**Amendments to the Drawings:**

The attached sheets of drawings include changes to Figs. 1, 2, 3 and 4. These sheets, which include Figs. 1-2-3a,b-3c and 4, replace the original sheets including Figs. 1-4.

Figure 1 (Prior art)

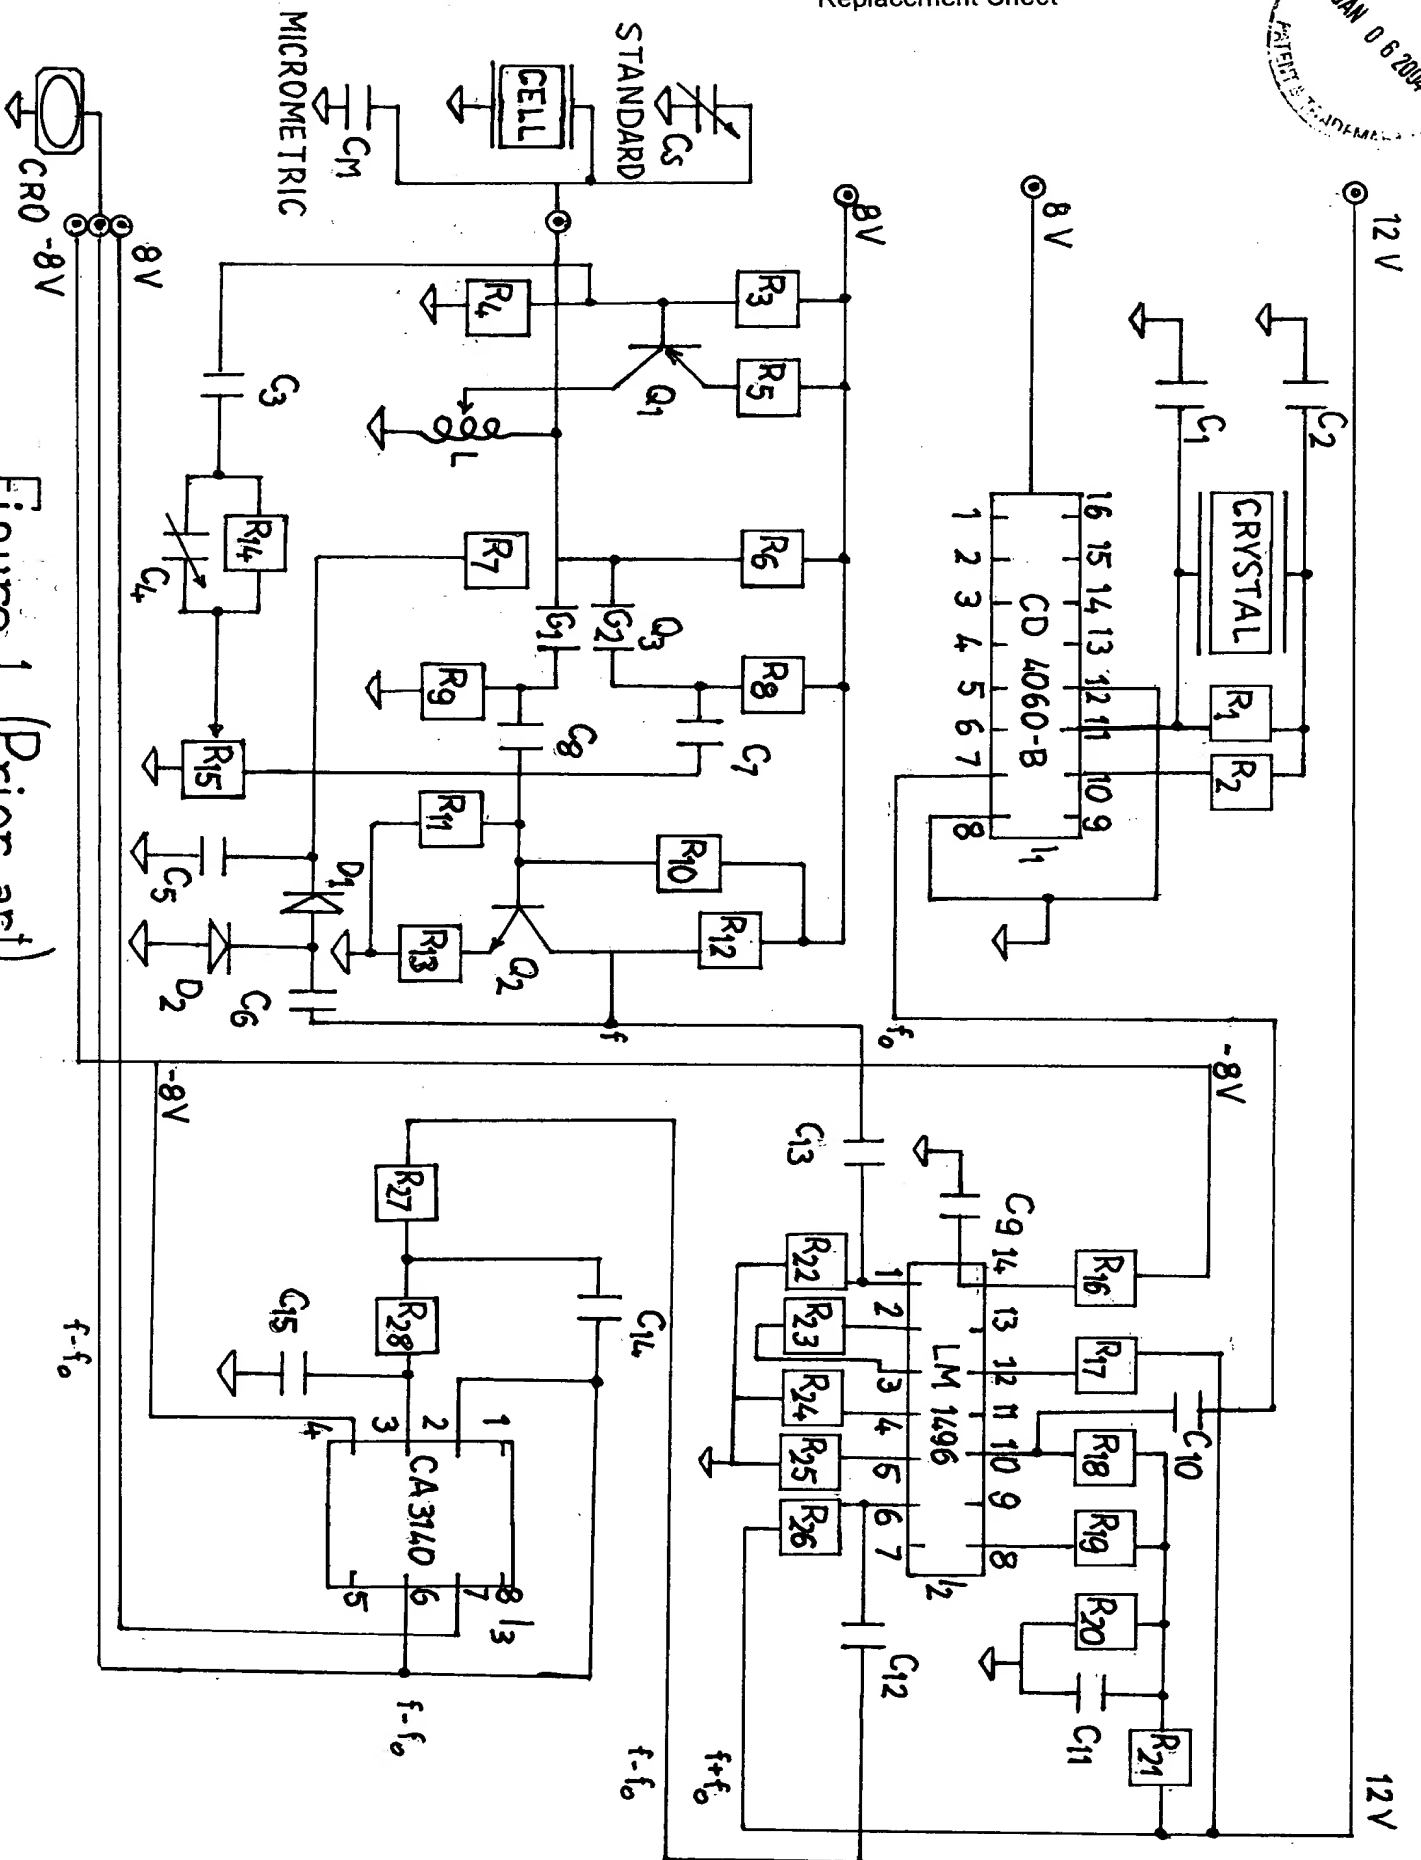
In Figure 1, it is indicated that: it corresponds to Prior Art, the size and clarity of letters and numbers has been improved and names of components have been rewritten.

Figure 2

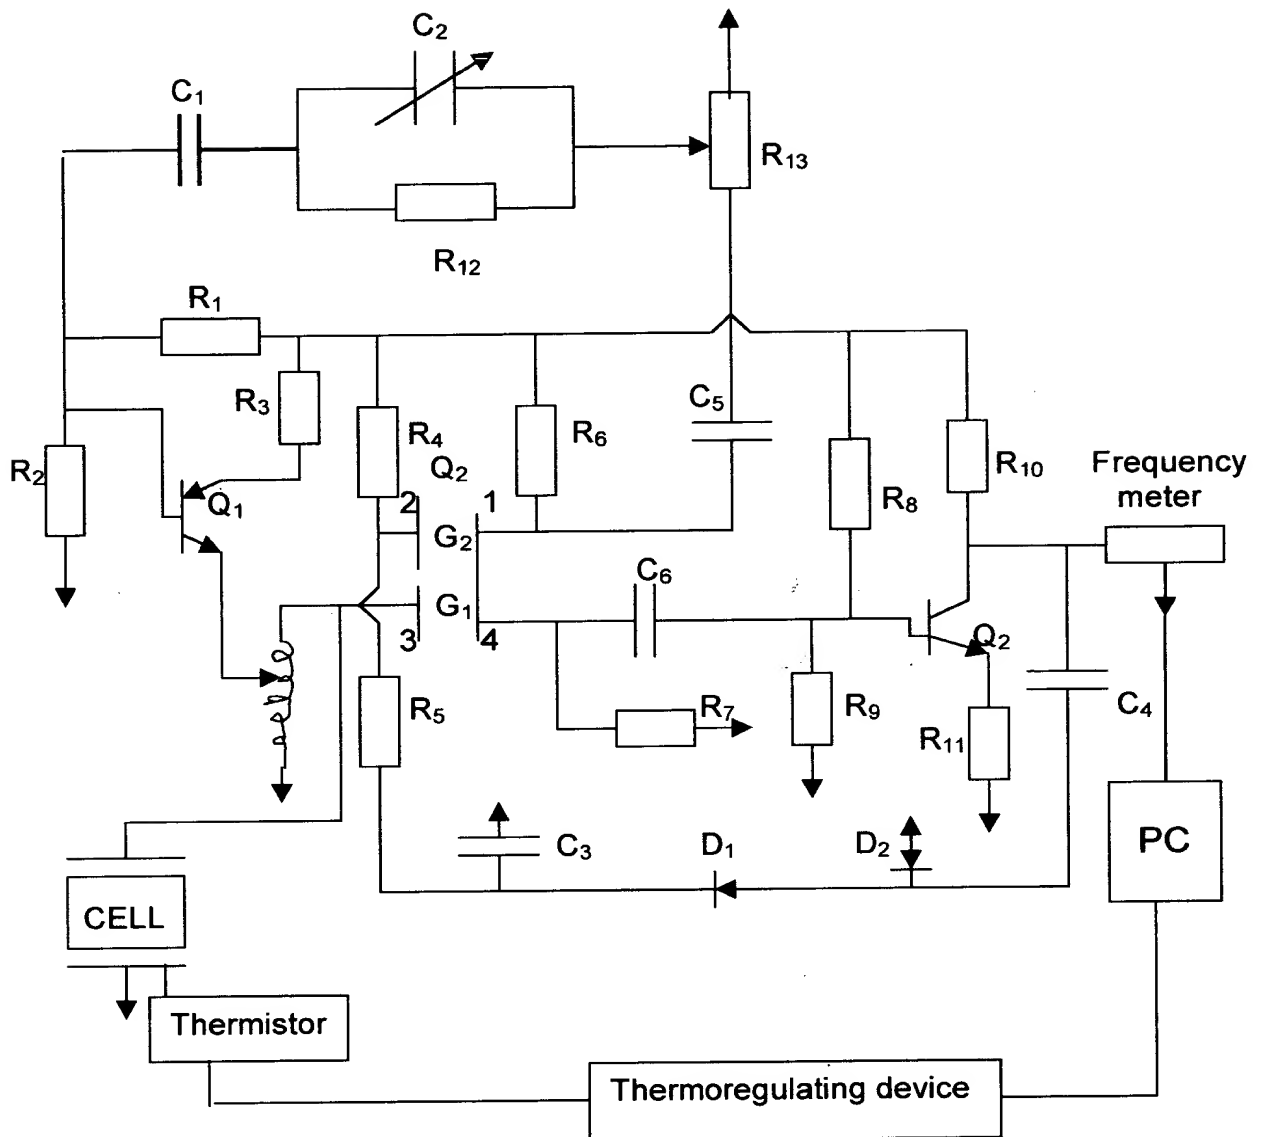
In Figure 2, the thermistor and thermoregulating device have been added as well as their connection to the PC.

Figure 3

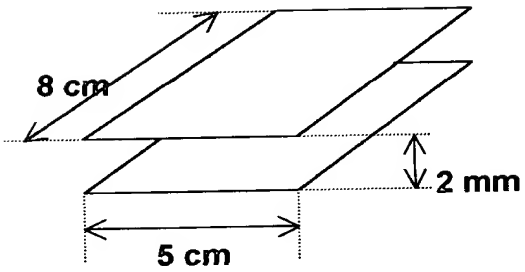
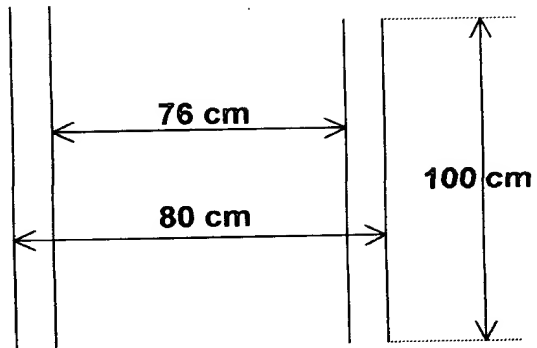
Figure 3, has been subdivided into Figure 3a,b and Figure 3c as requested.

Figure 4

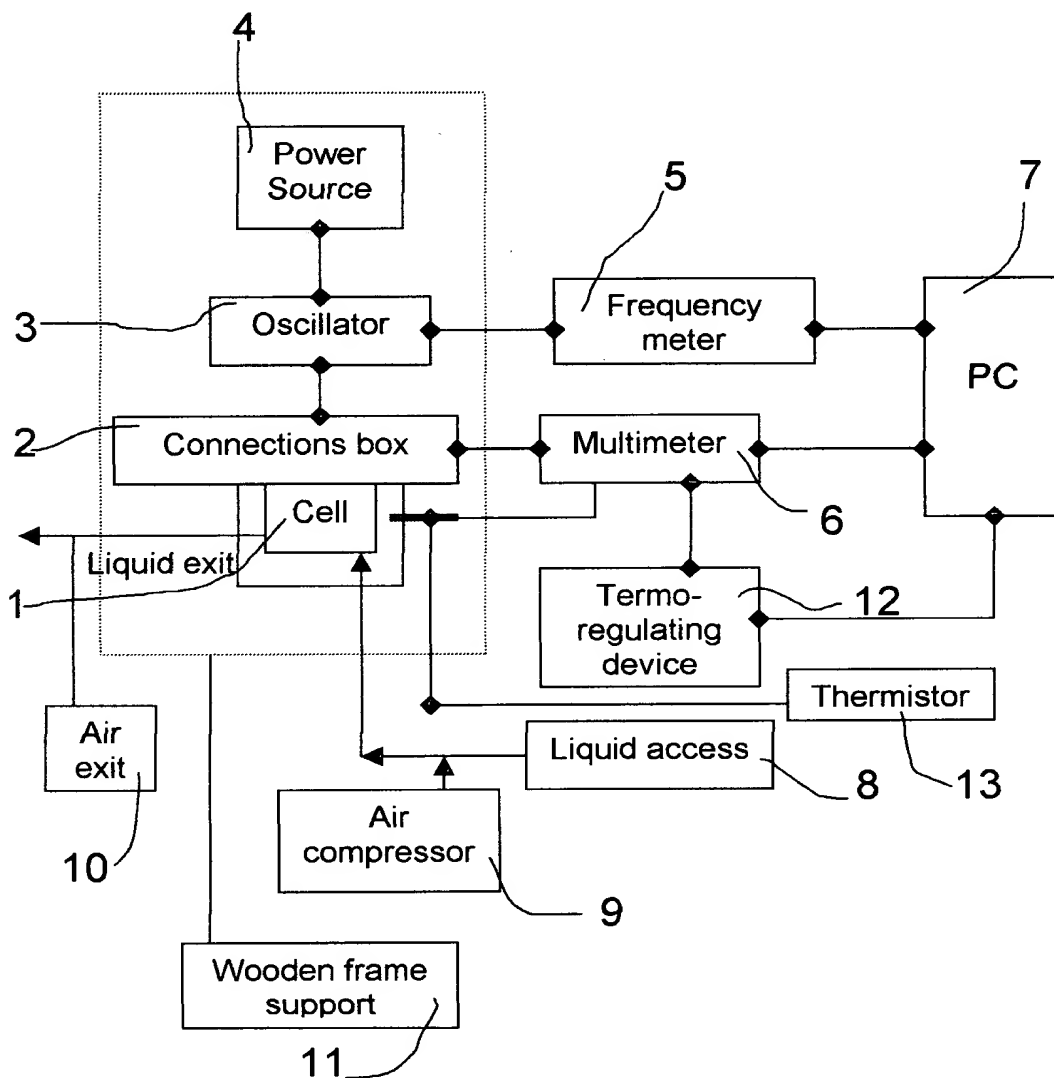
In Figure 4, previously omitted elements 12 and 13 and connections have been added.
